EPA Region 8
Underground Injection Control (UIC) Program
Response to Public Comments

Class III Area Permit No. SD31231-00000, Aquifer Exemption Decision
And
Class V Area Permit No. SD52173-00000

Powertech (USA) Inc.
P.O. Box 448
Edgemont, South Dakota 57735

Final Permit issuance: November 24, 2020

Figure K. Compilation of the USGS interactive earthquake map and Google maps showing the location of the January 5, 2004 earthquake located at latitude 43.598°N longitude 103.995°W northwest of the Dewey Fault Zone.

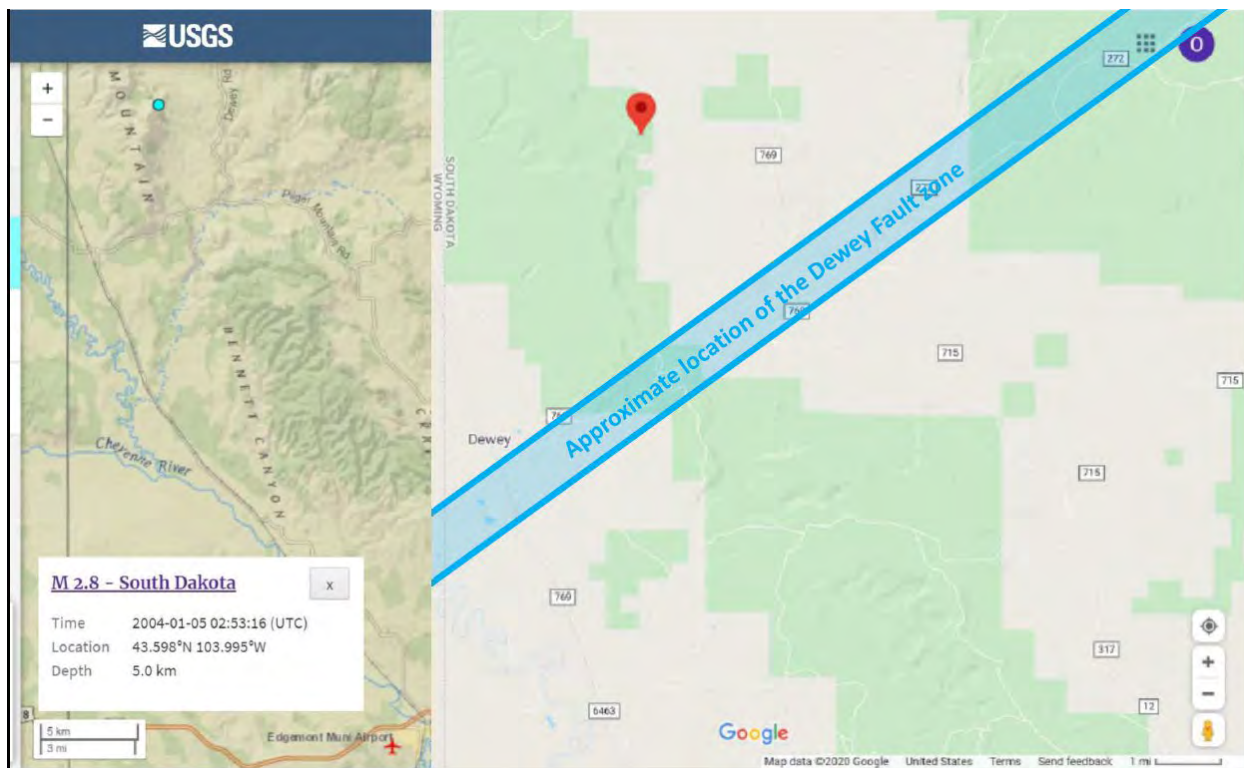
Figure J shows the nearest recorded earthquake to the Dewey-Burdock Project Site is the one that occurred on January 5, 2004, located north of the Project Site. Figure K shows this earthquake location on the [USGS Earthquake Hazards Program interactive map](#). This earthquake was located at latitude 43.598°N and longitude 103.995°W. This location plotted on Google maps with the Dewey Fault zone location added shows that this earthquake was not located in the Dewey Fault zone.

Figure L. The relative locations of the Dewey-Burdock Project Site and Town of Buffalo Gap locations in the Black Hills and Inyan Kara groundwater flow direction.

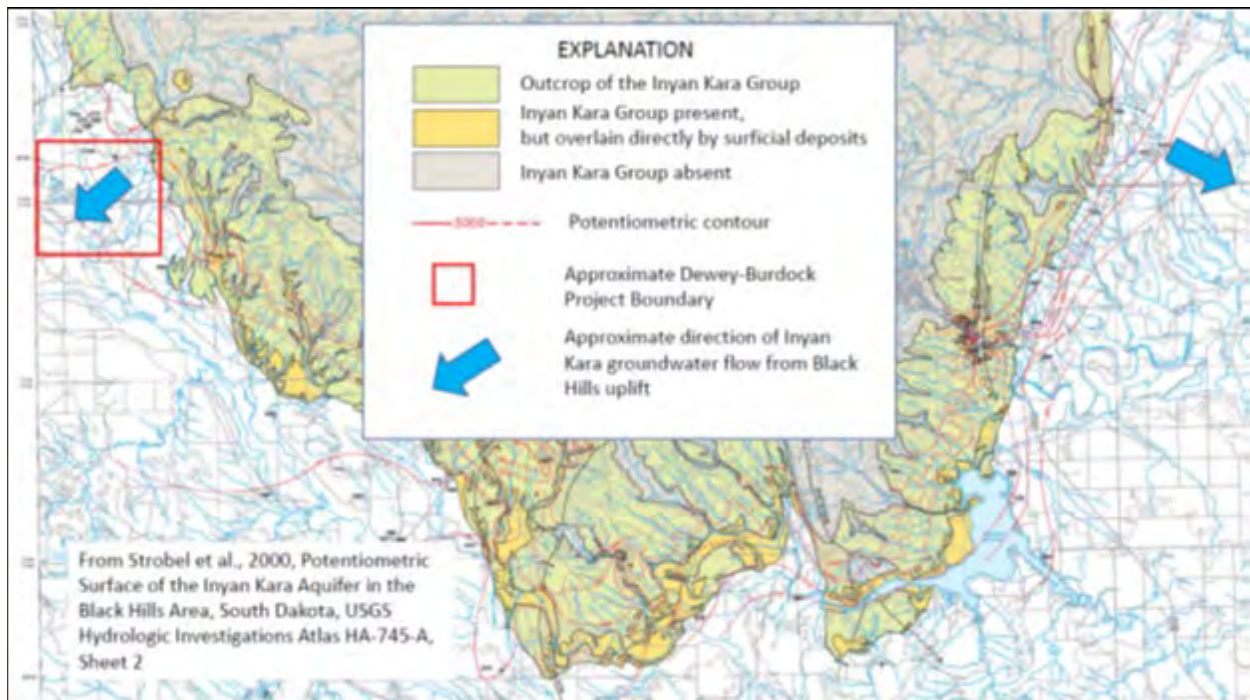
EPA has investigated the injection zone aquifer flow directions from the Dewey-Burdock Project Area relative to the Town of Buffalo Gap, South Dakota. Figure L is the southern portion of Sheet 2 from Strobel et al., 2000, which shows that the Dewey-Burdock Project Site and Buffalo Gap are located on opposite sides of the Black Hills. (Strobel et al., 2000). The Inyan Kara aquifer groundwater flow at the two locations is in opposite directions, as indicated by the potentiometric surface contours that approximately follow the dip of geologic strata away from the Black Hills uplift.

Figure M. Minnelusa aquifer groundwater flow directions around the southern portions of the Black Hills based on Figure 16 from Carter et al., 2001.

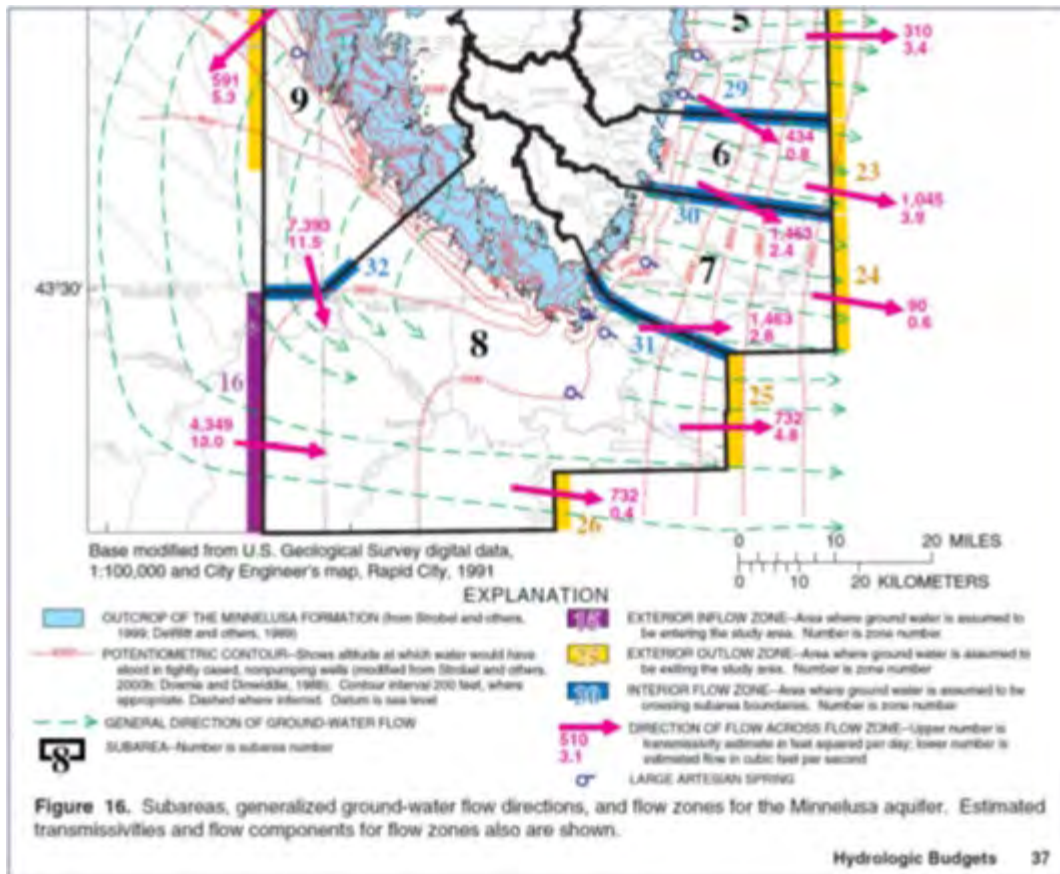
Figure M below shows the groundwater flow directions of the Minnelusa injection zone aquifer at the Dewey-Burdock Project Site and at the Town of Buffalo Gap from Carter et al., 2001, *Hydrologic budgets for the Madison and Minnelusa aquifers, Black Hills of South Dakota and Wyoming, water years 1987-96*: USGS Water-Resources Investigations Report 01-4119. Buffalo Gap is located near the southern border in subarea 7 and the Dewey-Burdock site is located near the pink arrow crossing the boundary between subareas 8 and 9. Based on this Minnelusa aquifer flow direction map, Class V injectate into the Minnelusa aquifer at the Dewey-Burdock project site will not reach the Town of Buffalo Gap.

Based on aquifer flow direction information, the groundwater flowing from the Dewey-Burdock site will not reach Buffalo Gap. Because the proposed Dewey-Burdock operations will have no impact on the aquifers present at Buffalo Gap, EPA does not agree that the geographic scope of the EJ Analysis should be revised to include the Town of Buffalo Gap. For the same reason, EPA does not agree that it would be appropriate to extend enhanced public participation and outreach specifically to the residents of Buffalo Gap.

Figure N. Elevation of the Minnelusa Formation top surface (Source: Carter and Redden, 1999, Sheet 2)

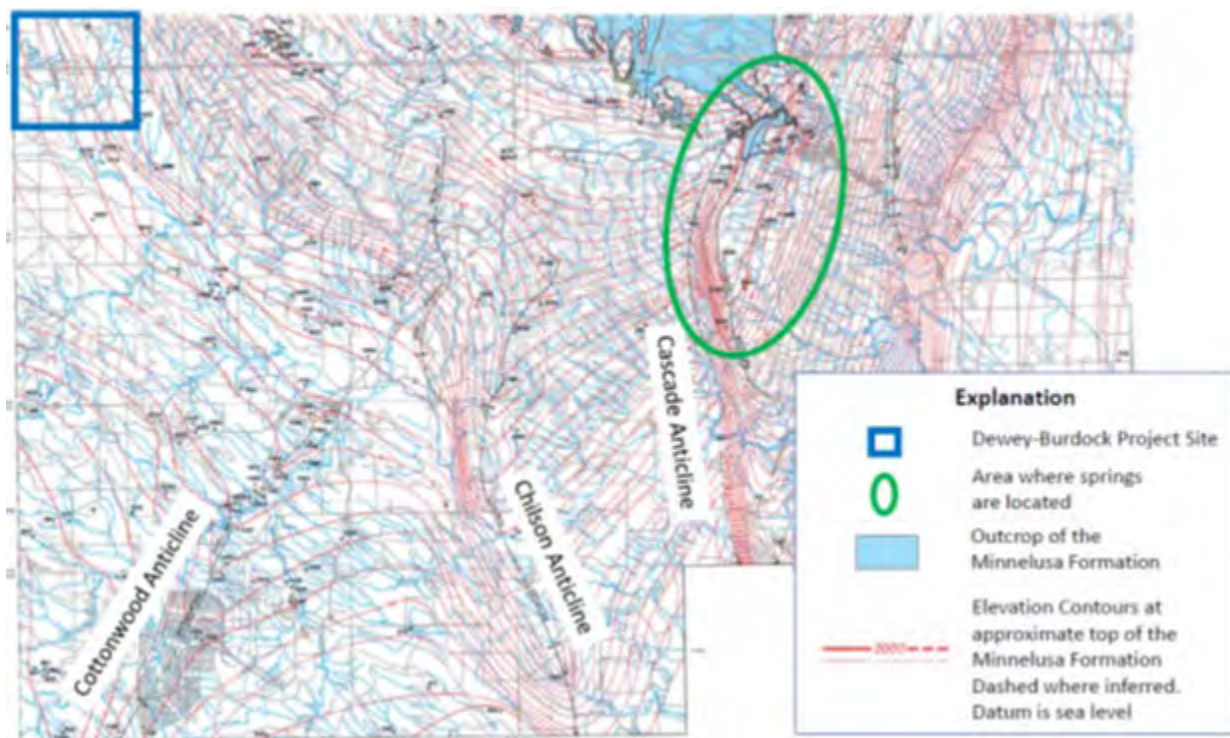
locations where the Minnelusa groundwater flows to the ground surface are at springs near the Minnelusa outcrop around the Black Hills. Figure N shows the elevation of the top of the Minnelusa Formation from the Sheet 2 map from Carter and Redden, 1999. (Carter and Redden, 1999, Sheet 2) The springs are located in the green circle in Figure N; the Dewey-Burdock Project Area is located inside the blue square. The Minnelusa Formation where the springs are located, occurs at a higher elevation than the Minnelusa injection zone in the Dewey-Burdock Project Area. Although the Minnelusa Formation top elevation is not the same as the aquifer groundwater level and the direction of the Minnelusa Formation dip is not exactly the same as the groundwater flow direction, relative formation top elevation and direction of formation dip are a useful approximation in this case. EPA concludes that injectate flowing from the Dewey-Burdock Project Site would have to flow uphill/upgradient to reach these springs and thus would not reach the locations of these springs. In addition, the Cottonwood, Chilson and Cascade anticlines located south of the Black Hills are like hills raising the Minnelusa Formation top to a higher elevation and deflect Minnelusa groundwater flow further south away from the locations of these springs.

Based on this analysis, EPA concludes the Class V disposal well injectate will not travel to the locations of Minnelusa springs to be discharged to the ground surface; therefore, Class V injection activities will not impact surface water, including the Cheyenne River, the Cheyenne River Indian Reservation, the Pine Ridge Indian Reservation, or other downstream communities.

Figure P. Minnelusa aquifer groundwater flow direction map from Figure 17, Driscoll et al., 2002

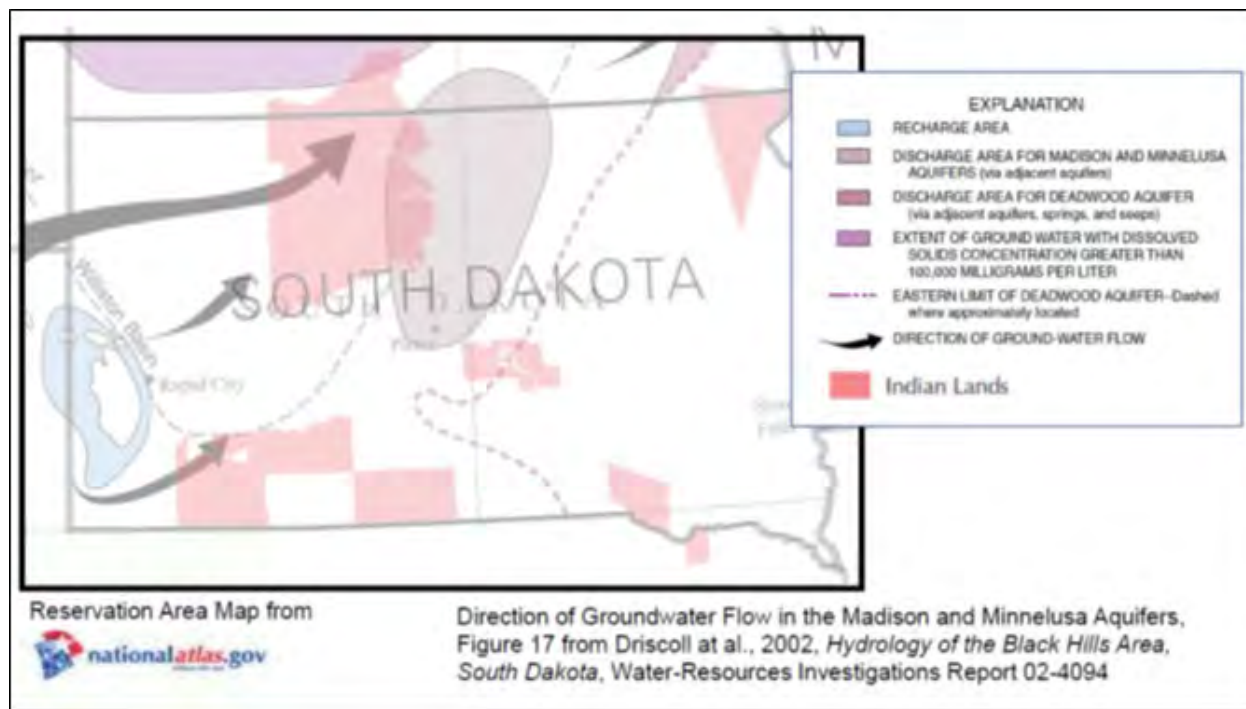
area in the Black Hills to a discharge area identified in this paper. As shown in the map in Figure P, the authors hypothesize that the Minnelusa aquifer groundwater flows from the Dewey-Burdock site and around the southern end of the Black Hills toward the Williston Basin, crossing underneath the northwestern portions of the Pine Ridge Reservation. The map shows a discharge area for the Madison and Minnelusa aquifers in an area that coincides with the eastern portion of the Cheyenne River Indian Reservation.

Figure Q. Locations of springs emanating from or passing through the Minneulsa aquifer, from Figure 8 of Naus et al., 2001.

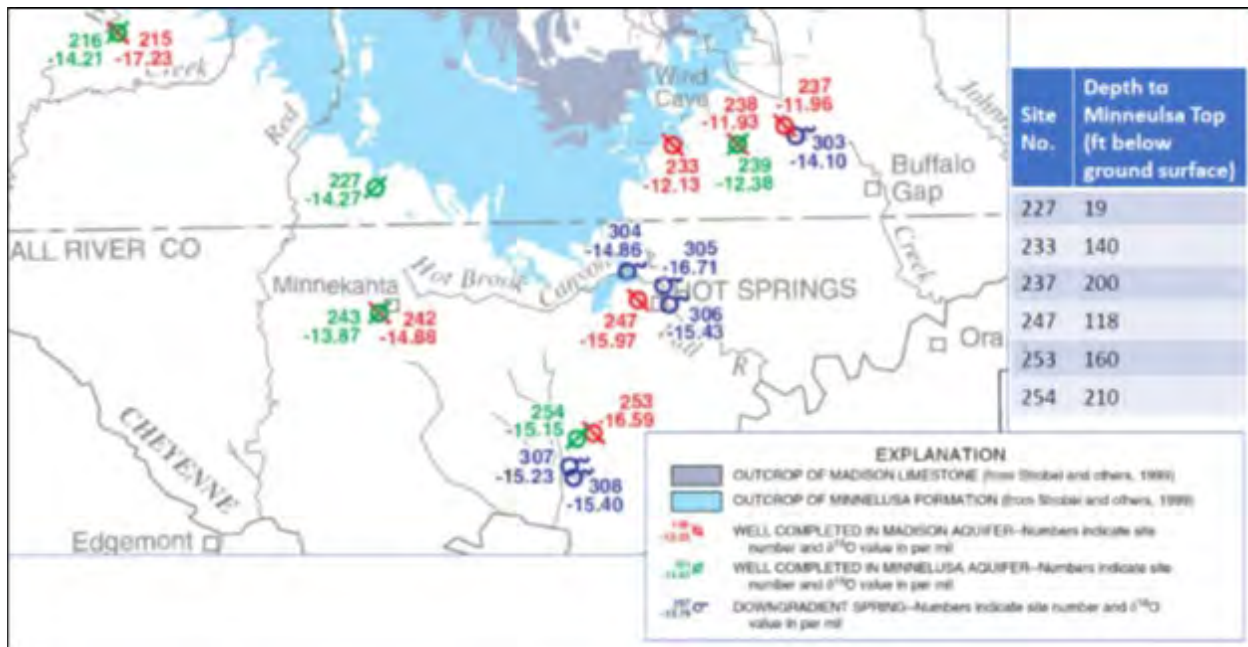
EPA examined oil and gas test wells located near the northwest portion of the Pine Ridge Indian Reservation to determine the depth of the Minnelusa aquifer in the area and found the top of the Minnelusa aquifer is more than 3,800 feet below ground level in this area, which is too deep to flow to ground level. Springs emanating from, or passing through, the Minnelusa aquifer occur where the top of the Minnelusa aquifer occurs closer to the ground level. For example, at the springs shown in Figure Q, from Figure 8 of Naus et al. 2001, the top of the Minnelusa is approximately 200 feet or less below ground level, based on nearby private well logs. Based on the elevation of the top of the Minnelusa Formation shown in Carter and Redden, 1999, the springs occur in areas located at a higher elevation than the Minnelusa injection zone at the Dewey-Burdock Project Site. Carter and Redden, 1999, provides estimates of how the Chilson and Cascade anticlines affect the Minnelusa Formation elevation. As a result, the flow path of Class V injectate would be deflected to the south and would essentially have to flow uphill to reach these springs where Minnelusa groundwater flows to the surface.

Figure R. Map showing area of possible upward leakage from the Madison and Minnelusa aquifers into Inyan Kara aquifers and extent of the Arikaree and Ogallala aquifers (Sources: Peter et al., 1986, Figure 8 and Weeks, et al., 1988, Figure 1)

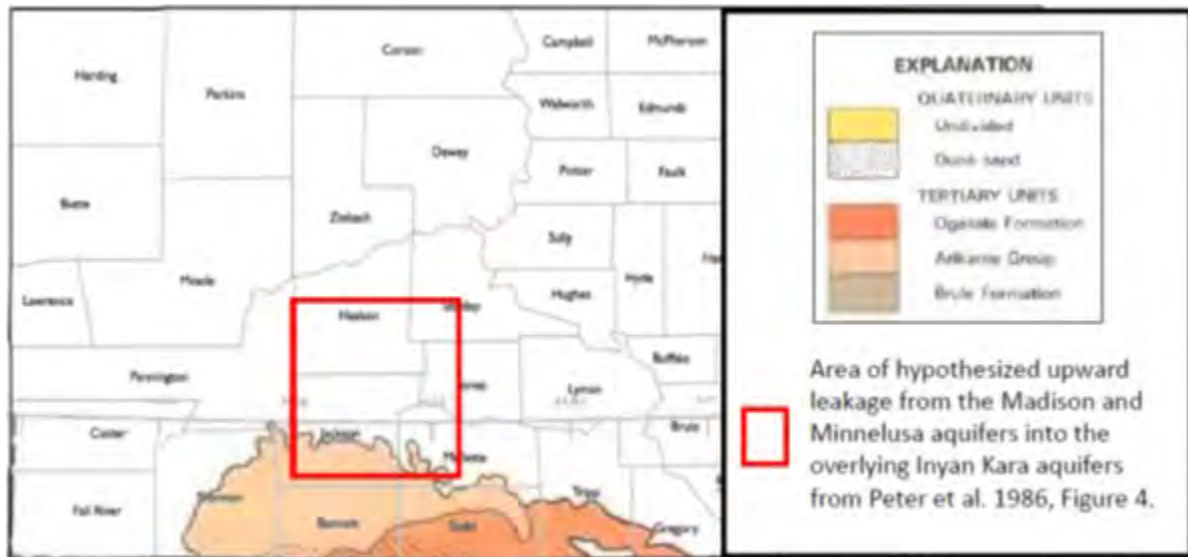
Based on lineament analysis and review of Inyan Kara groundwater quality data, Peter et al., 1986, hypothesized upward leakage from the Madison and Minneulsa aquifers into the Inyan Kara aquifers in an area within portions of Jackson, Melette, Haakon, Stanley and Jones Counties in South Dakota. (Peter, K.D., et al., 1986, *Lineaments: Significance, Criteria for Determination, and Varied Effects on Ground-Water Systems—A Case History in the Use of Remote Sensing*, Geotechnical Applications of Remote Sensing and Remote Data Transmission, ASTM STP 967, A. I. Johnson and C. B. Pettersson, Eds., American Society for Testing and Materials, Philadelphia, 1988, pp. 46-68.) Figure R shows the location of this area overlaid on a map of the Arikaree and Ogallala aquifers in South Dakota documented in Weeks, et al., 1988. (Weeks, J.B., et al, 1988, *Summary of the High Plains Regional Aquifer-System Analysis In Parts of Colorado, Kansas, Nebraska, New Mexico, Oklahoma, South Dakota, Texas, and Wyoming*, USGS Professional Paper 1400-A, at p. A4) Upward leakage from these lower aquifers into the Inyan Kara aquifers does not necessarily result in upward leakage into the overlying Arikaree and Ogallala aquifers in this location. EPA reviewed logs from oil and gas test wells in Jackson County and determined the top of Inyan Kara is 2800 to 2900 feet below ground surface. Approximately 2000 feet of overlying strata, most of which are confining zones, separate the top of Inyan Kara aquifer from the Arikaree and Ogallala aquifers. EPA concludes that Inyan Kara groundwater does not flow into the Arikaree and Ogallala aquifers on the Pine Ridge Indian Reservation.

EPA has investigated the area identified as a discharge area for the Minnelusa and Madison aquifers in the area shown in Figure P that coincides with the eastern portion of the Cheyenne River Reservation. The discharge area represents the area where Madison and Minnelusa groundwater is moving upward into the Inyan Kara aquifers (Downey, J.S and Dinwiddie, G.A, 1988, *The Regional Aquifer System Underlying the Northern Great Plains in Parts of Montana, North Dakota, South Dakota, and Wyoming-Summary*, USGS Professional Paper 1402-A). Based on oil and gas test well logs EPA reviewed, the depth to the top of the Minnelusa aquifer in the area of discharge is approximately 3,000 feet below ground level and the top of the Inyan Kara aquifer is approximately 2,000 feet below ground level. According to Howells, 1979, (Sheet 1) the Pierre Shale is present at the surface of the eastern portion of the Cheyenne River Indian Reservation. (Howells, L., 1979, *Geohydrology of the Cheyenne River Indian Reservation, South Dakota*, USGS Hydrologic Investigations Atlas HA-585, Sheet 1) Most of the intervening geologic units between the top of the Inyan Kara, including the Pierre Shale, are confining units. Based on this information, EPA concludes that neither the Minnelusa nor the Inyan Kara injection zones discharge to ground level at the Cheyenne River Indian Reservation. EPA examined test oil and gas well logs and found that along the eastern edge of the Cheyenne River Indian Reservation the top of the Inyan Kara ranges from 1500 in the southeast to 2800 in the northeast. The top of the Inyan Kara deepens from south to north as it descends further into the Williston Basin. Driscoll et al., 2002, characterizes Inyan Kara groundwater as moderately saline with increasing salinity toward the deep parts of the Williston and Powder River Basins. Because of the depth and salinity of the Inyan Kara aquifers at the Cheyenne River Indian Reservation, these aquifers would not be developed for use.

Figure S. Anticipated Project-Wide Flow Rates during Uranium Recovery and Groundwater Restoration

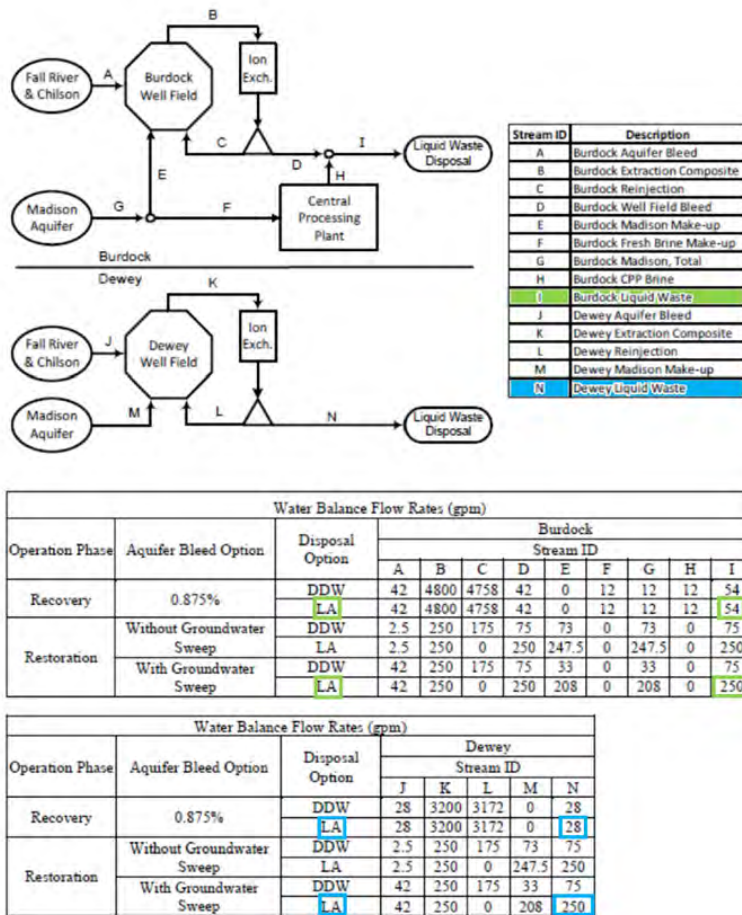
that Figure 7.1 of the Class III permit application and Table 5.3-2 of the Large Scale Mine Permit Application show that the maximum anticipated liquid waste flow rate during concurrent operations and aquifer restoration under the land application option is 582 gpm. Powertech requests correcting this statement as follows:

EPA agrees with Powertech's proposed changes in this comment and has made edits in the CEA as Powertech proposes in this comment. The 582 gpm flow rate is derived by adding up the waste stream flows from Figure 7.1 of the Class III permit application. The 582 gpm flow rate is the total of Burdock Liquid Waste (Stream ID I) during the uranium recovery phase for the land application disposal option (54 gpm), plus Burdock Liquid Waste (Stream ID I) for the Restoration phase, with Groundwater Sweep, land application disposal option (250 gpm) outlined in green in the Figure S below, plus Dewey Liquid Waste (Stream ID N) during the uranium recovery phase for the land application disposal option (28 gpm), plus Dewey Liquid Waste (Stream ID N) for the Restoration phase, with Groundwater Sweep, land application disposal option (250 gpm) outlined in blue in the Figure S below. Those numbers add up to 582 gpm.
